**Subject:** March 19, 2014 Fukushima Public Meeting - Slide Presentation and Resolution Matrix  
**Sent Date:** 3/12/2014 6:18:30 PM  
**Received Date:** 3/12/2014 6:19:26 PM  
**From:** GUCWA Len (EXTERNAL AREVA)

# **U.S. EPR – Fukushima Path to Closure**

U.S. EPR Design Certification

Figure 9.4.7-2—Containment Building Low Flow and Full Flow Purge Exhaust Subsystem

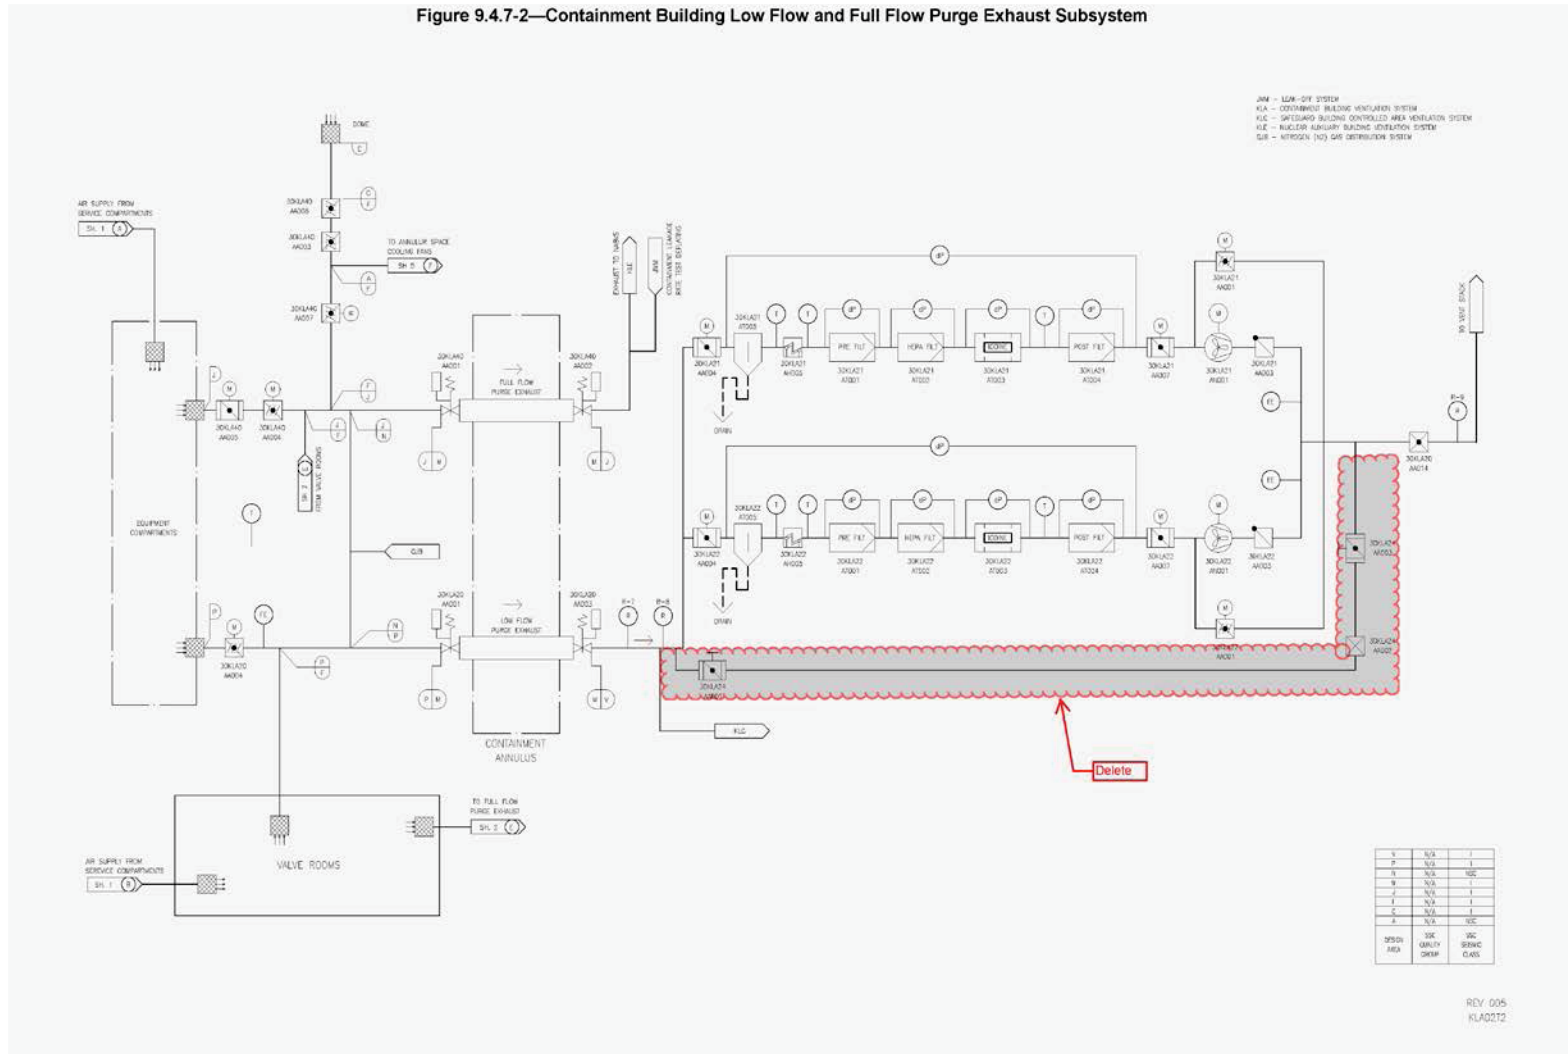
**Change:** Remove Seismic Category I bypass ducting and associated isolation dampers from low flow purge system.

**Rationale:** Resolve NRC questions on viability of containment venting strategy (RAI 598)

# Design condition of check valve on discharge of PCIP

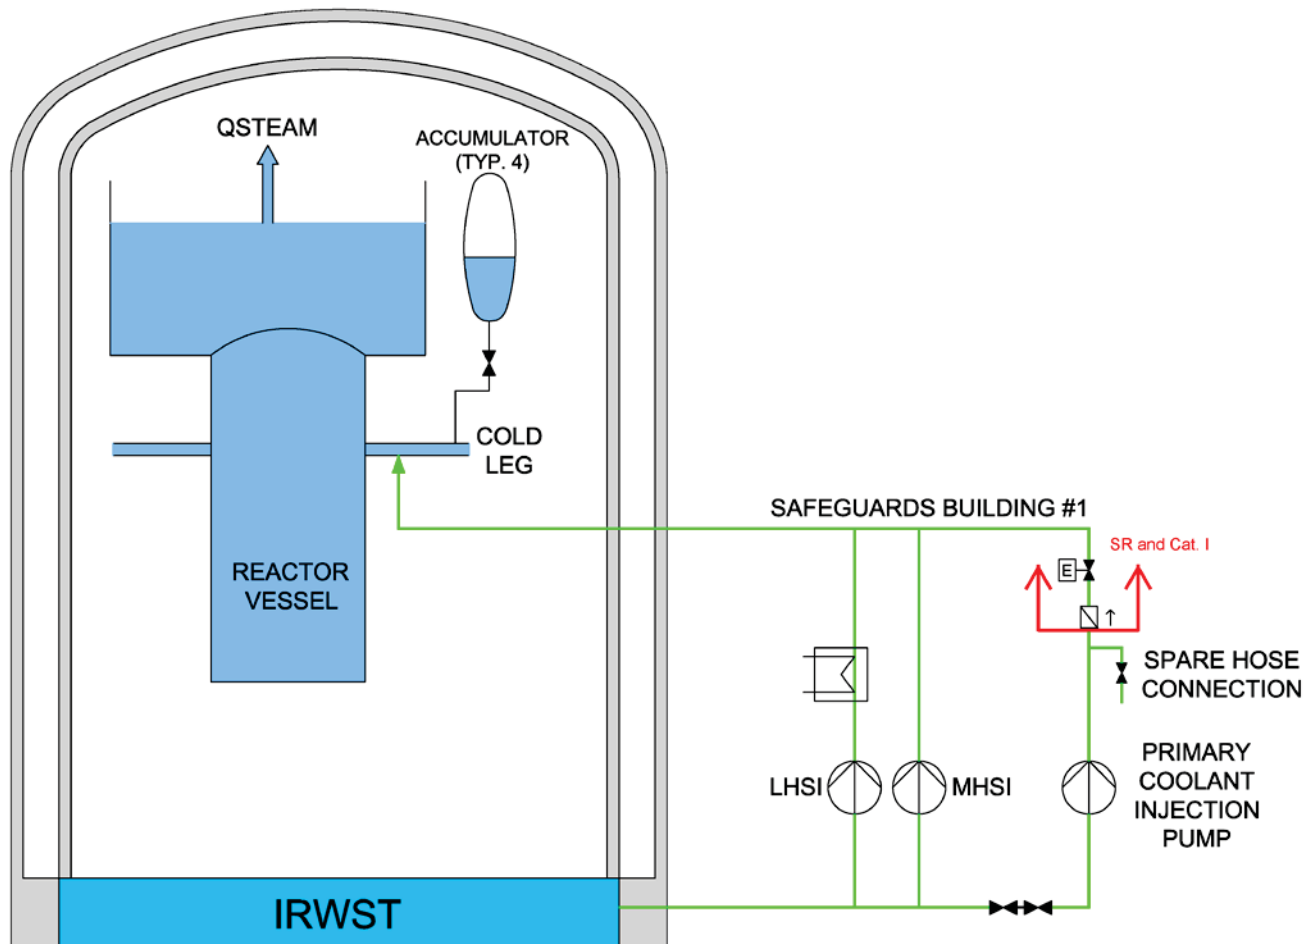
**Change:** Improve single failure protection at discharge of Primary Coolant Injection Pump (PCIP):

- ▶ Move the safety-related, Category I design boundary condition to include check valve 30JND11AA011.
- ▶ Require that 4" motor operated throttling valve (30JND11AA012) be closed and depowered in Modes 1-4

**Rationale:** Resolve Condition Report CR 2013-8207 and RAI 626 to improve single failure protection

Figure 19.2-22—Severe Accident Heat Removal System

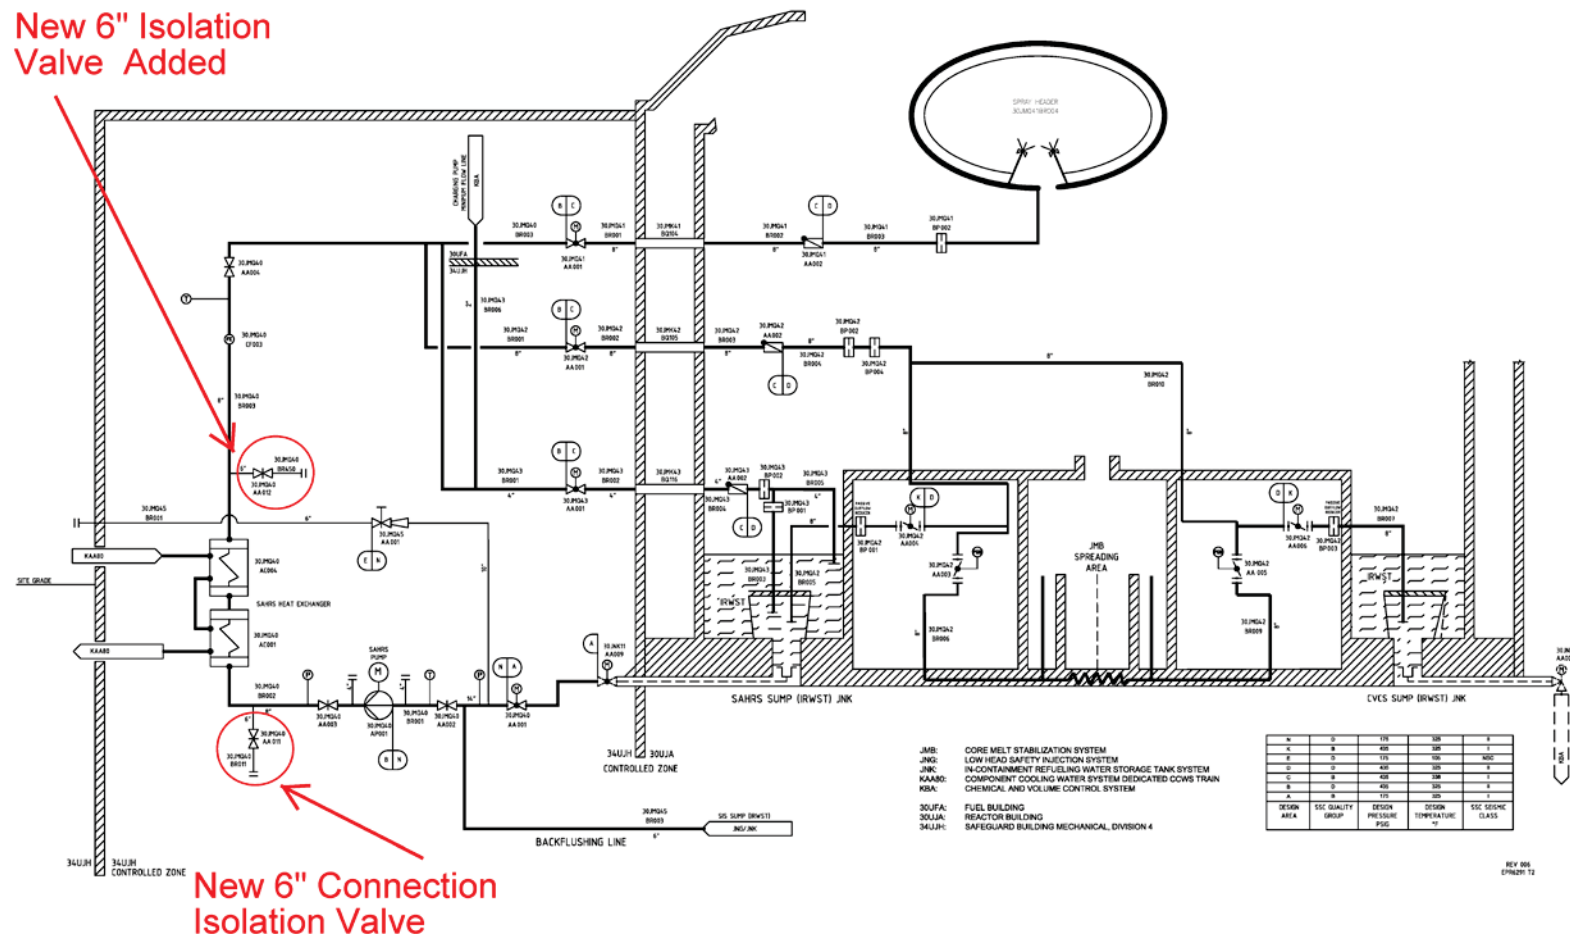
**Change:** Add new connection point to SAHRS and increase size of existing connection point

- ▶ New 6" branch line (30JMQ40BR011) and 6" manual isolation valve 30JMQ40AA011 will be installed downstream of manual isolation valve 30JMQ40AA003.
- ▶ Branch line 30JMQ40BR450 will be increased to 6" and new 6" manual isolation valve 30JMQ40AA012 will be installed at existing flange connection.

**Rationale:** Resolve Condition Report CR 2013-5118 which identified inadequate design conditions of the flange connections on the suction side of the SAHRS Pump for use as a potential connection point for the portable spray pump discharge.

New 6" Isolation Valve Added
